Access Compliance Report

Public Rights-of-Way

(Curb Ramps)

Intersection ID: 47271	Main Street: SAVANNAH_HILLS_DR	Cross Street: LIDDINGTON_RD	Location: SW
ADA ID: F4741073CE2B	Ramp Type: BlendTrans1	Initial Pass/Fail: Pass	Overall Compliance: No
		Severity Score: 15

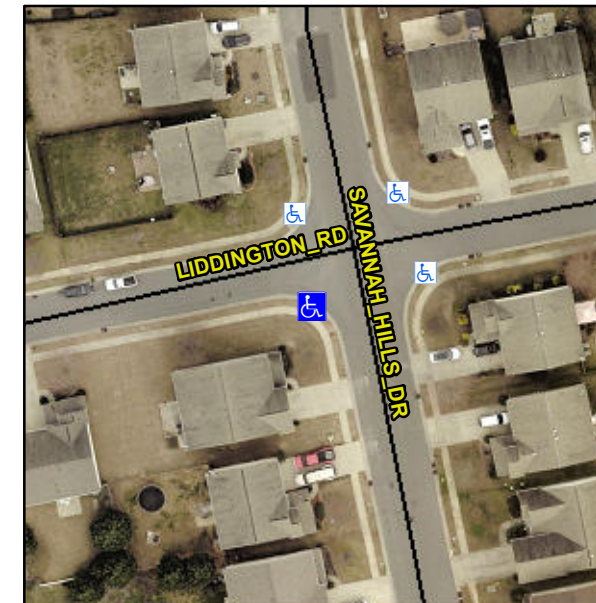
Possible Solutions:

Remove & Replace Curb Ramp With Two New Directional Ramps or Equivalent. Remove & Replace Gutter.

Not Found, R304.2.1, R305, R304.5.4
